NOTICE UNDER SECTION 96 OF ACT III OF 1901.

PLAN SHOWING PROPOSED BUILDING ON

PLOT No 89 SHEET No A-6

OLD TOWN QR

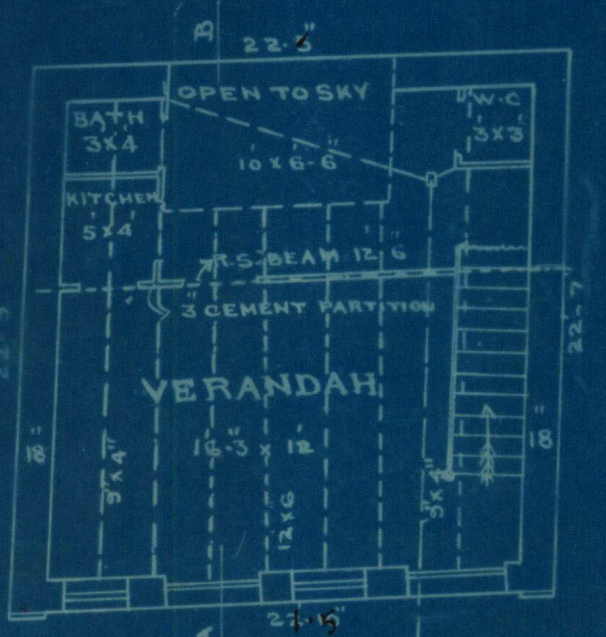
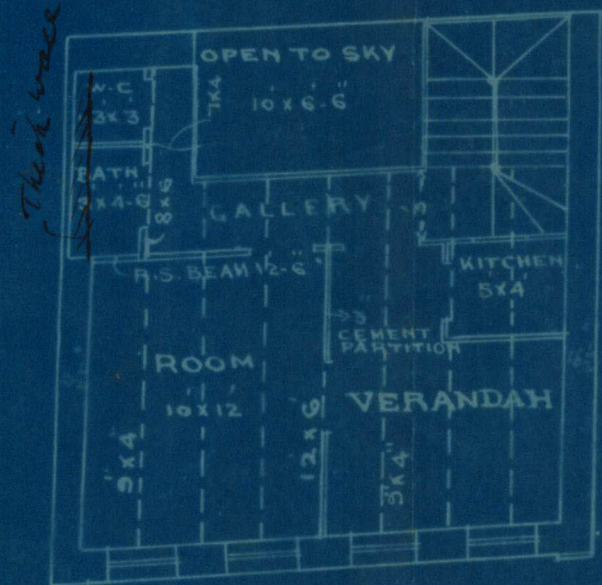
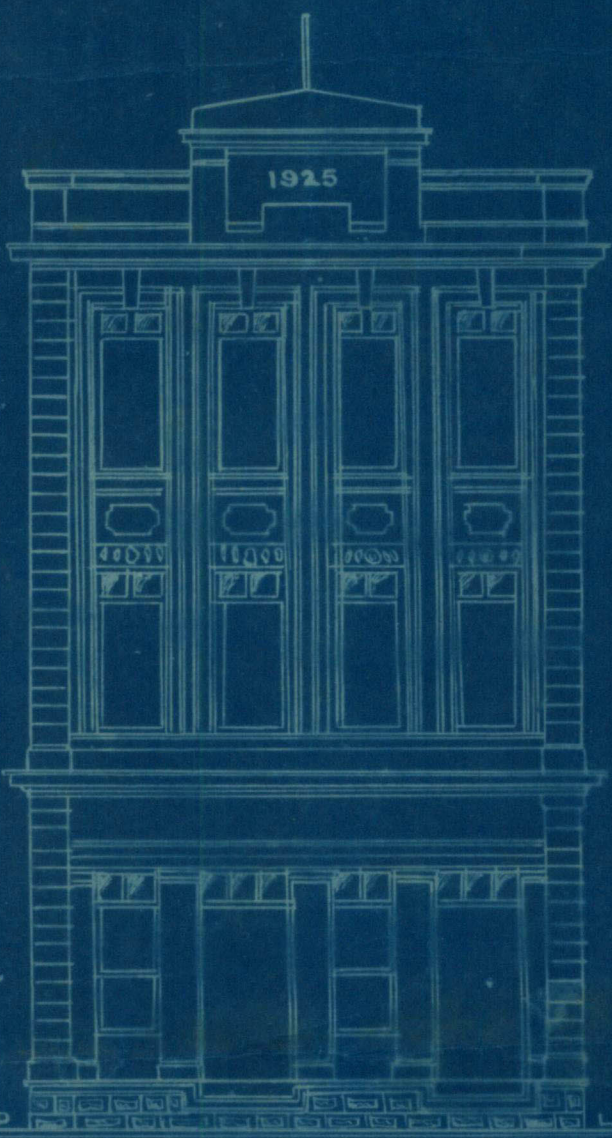
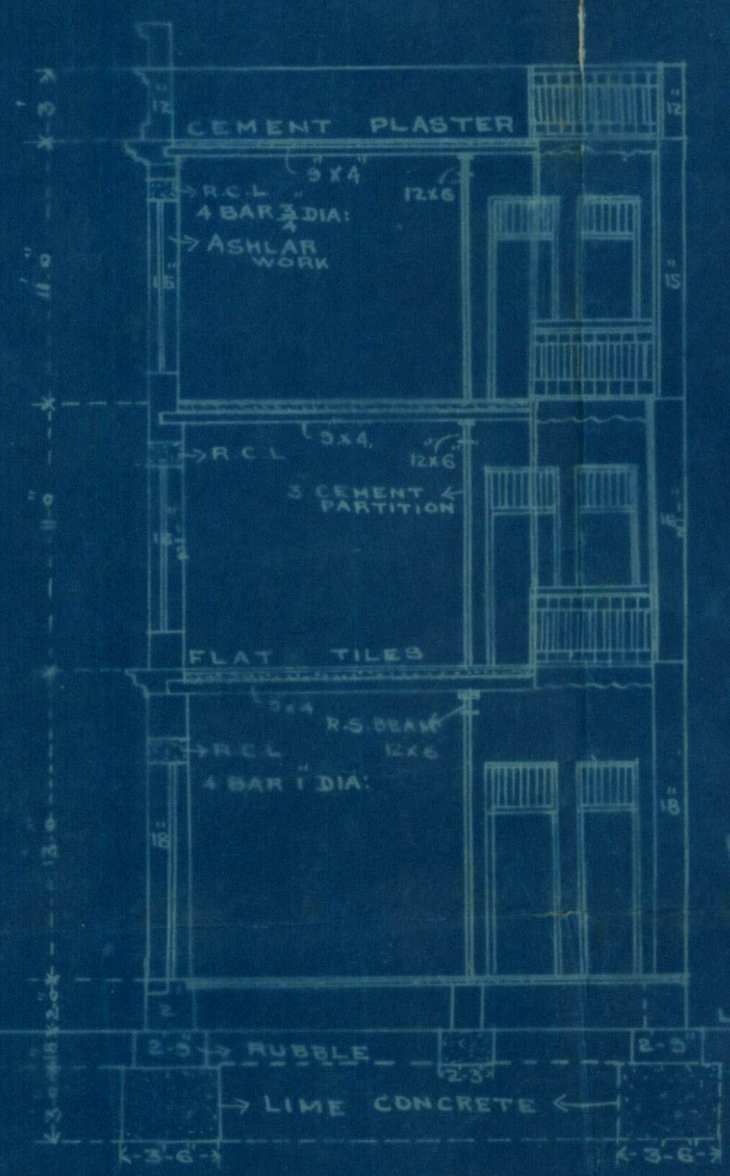
The exterior walls of bath & w.c. on 1st floor are not made according to the thickness as required by you; hence the objection is not removed.

Exterior wall must be made of 1 1/2 inches full thickness. ~~can be done by~~ ~~adding~~ 3/4 inch.

(1) Exterior wall of bath & W.C. must be of full thickness similar to main walls.

Corrected from 7/1/12 (2) Side dimensions of plot should be corrected as they do not tally with City Survey.

Remarks Submitted. Side measurement differs from
City Survey plan - necessary correction must be
made. There is no structure on the plot at
present.

Objections are removed & require no further compliance with. Sms 19/1/26. Ref Cy 27/1/26.

In reference to your
letter no 12484 dt 2/1/26 re. plat-
no 89 A-6 old Jamnagar, the side
dimensions of plat are corrected
& R.C. Beam is provided to build the
thick wall, it can not be built.
in thick wall as the area in front
of w.c. will be less than the
allowable area, therefore the plan
may now be passed easily. as
the plan was submitted on 28-11-25
& after one month & 5 days it is returned
to kind I approve it. as per as that the

The side dimensions have
since been corrected -
25/1/26
